5 Preferred infrastructure report

5.1 Increase in the clearance of the new bridge over The Terrace

5.2 Minor changes in bridge pier location and bridge type

Figure 5-1 Change in height of bridge and approach road – southern bank

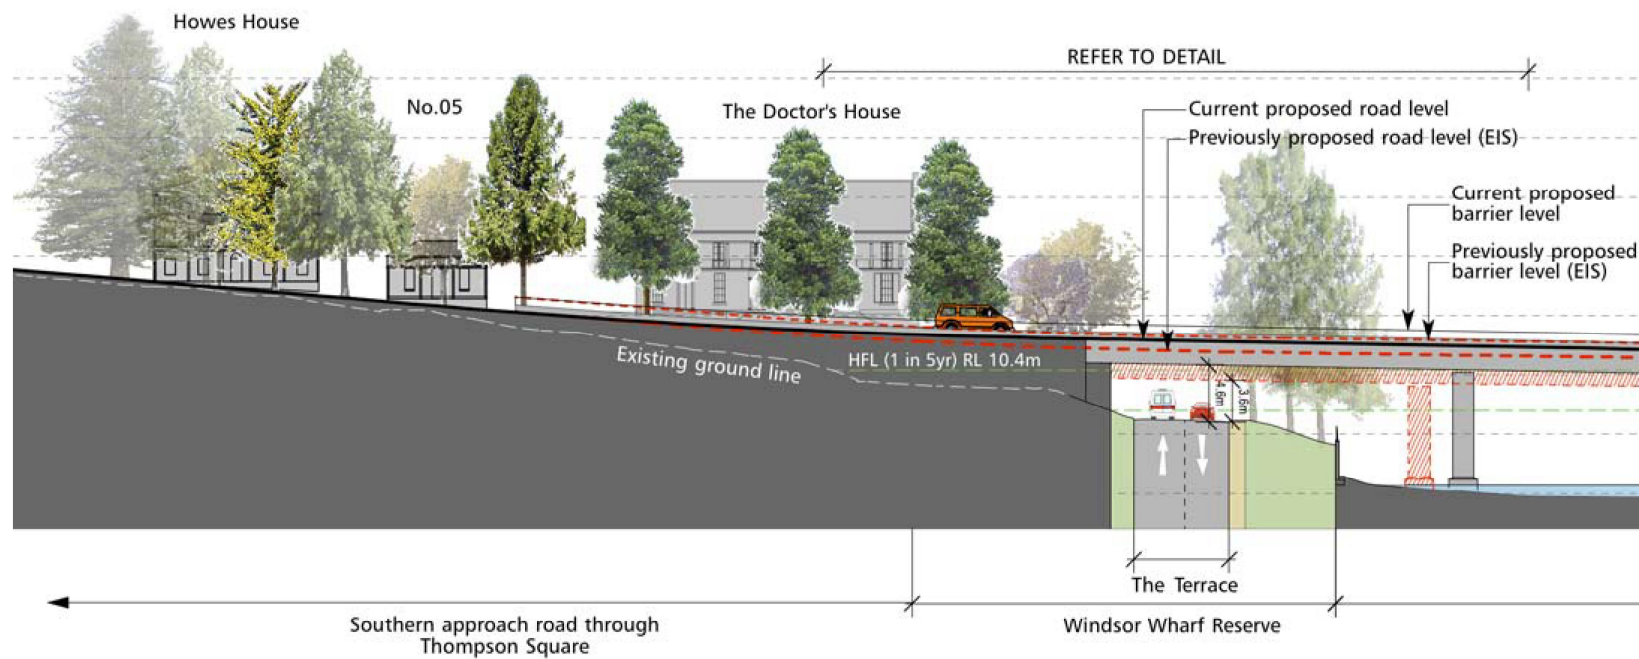
In consultation with Hawkesbury City Council and in response to submissions received during the exhibition of the EIS, RMS has now increased the proposed clearance of the new bridge over The Terrace from a minimum of 3.6 metres to a maximum of 4.6 metres to allow large coaches to directly access Windsor Wharf. Large coach access along The Terrace is required to allow the patrons of the Hawkesbury Paddle Wheeler to have easy access to Windsor Wharf.

To provide the additional clearance over The Terrace, the height of the southern end of the bridge would be increased. This would result in a one metre higher bridge and abutment at the southern end, and a marginally higher 45 metre long section of the southern approach road through Thompson Square between the driveways of Number 4 Bridge Street to the southern abutment. South of the driveway of Number 4 Bridge Street and in front of the heritage listed properties of Number 6 and Number 10 Bridge Street, the height of the southern approach road would remain the same as that presented in the EIS. The grade of the bridge would also increase slightly from 1.6 to 1.9 per cent.

Figure 5-1 and **Figure 5-2** presents the difference in heights of the modified project in comparison to the project presented in the EIS.

Figure 5-3 Cross-section of double T bridge

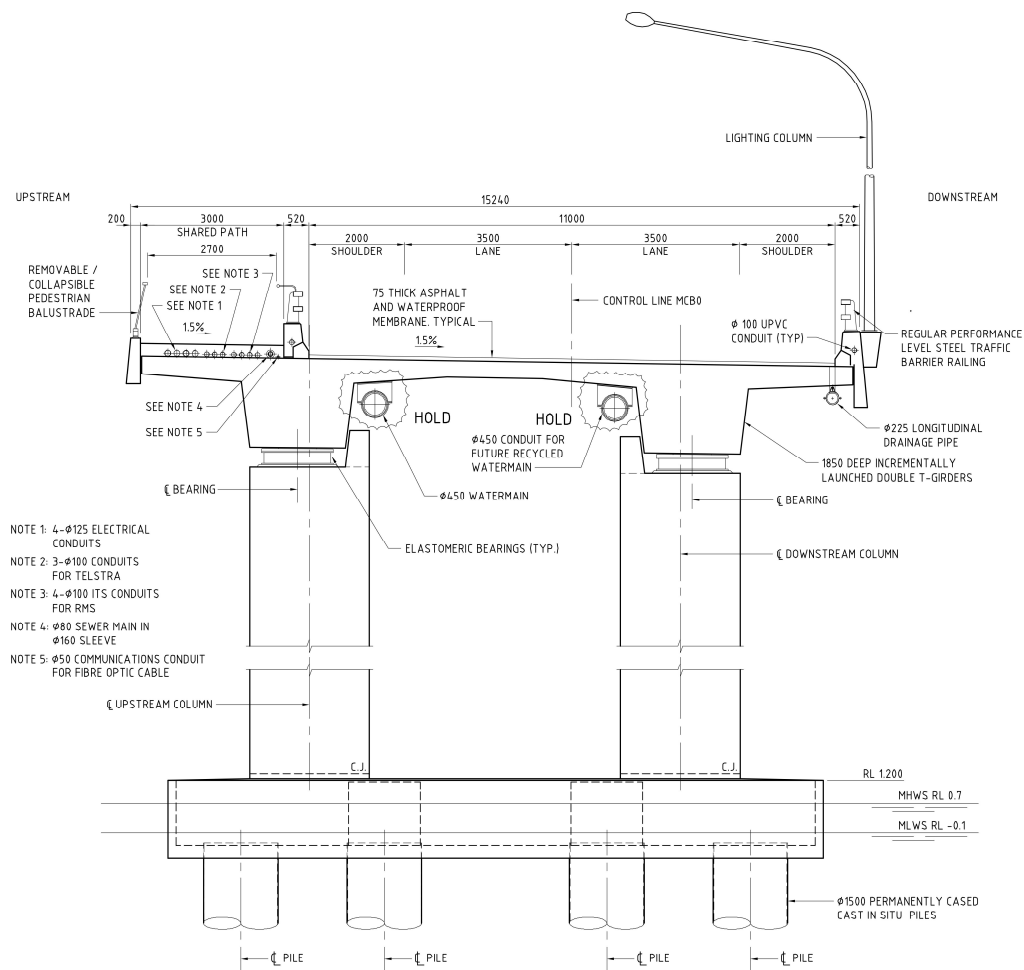
- Instead of a double box girder bridge as shown in Figure 5-4 of the EIS, a double T bridge would be constructed. A double T bridge would have a slightly shallower superstructure than a double box girder bridge but would otherwise have similar features to those described in the EIS. It would be incrementally launched as described in the EIS. **Figure 5-3** shows a cross section of the double T bridge.
- To accommodate the double T bridge, the location of the bridge piers in the Hawkesbury River would change slightly from those presented in the EIS. The changes in pier locations are presented in **Figure 5-4**. The southern and northern piers closest to the respective river banks would be located further from the banks and there would be a minor change in location for one of the central piers.

Figure 5-4 Changed pier locations – Note grey indicates original pier location and black indicates new pier location

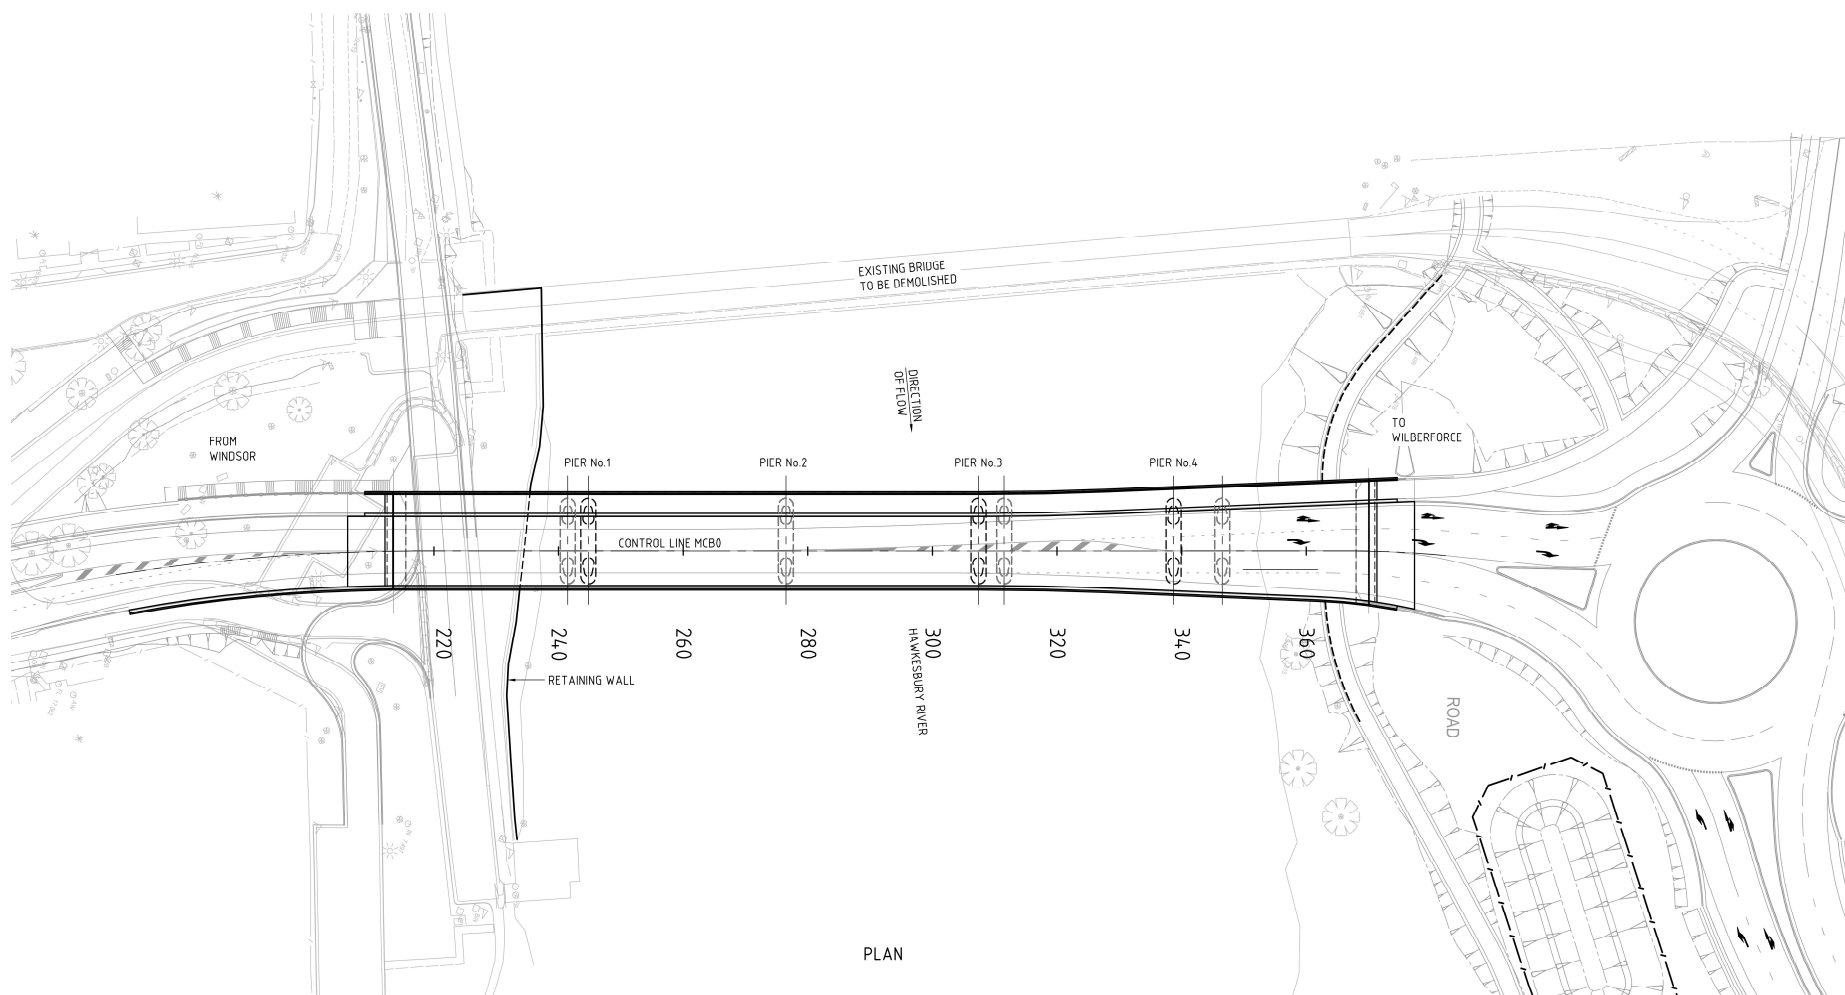
The change in the location of the bridge pier closest to the southern river bank would result in a minor reduction in direct impacts on maritime archaeological remains and may reduce the scour of the southern bank during flood events. Additionally, the proposed location and spacing of the piers away from the river bank, combined with the proposed increase in the clearance of the bridge over The Terrace, would enhance the perception of space along the foreshore and under the bridge and open up the views from The Terrace. This is explained further in the Landscape Character and Visual Impact Assessment Addendum in **Appendix D**.
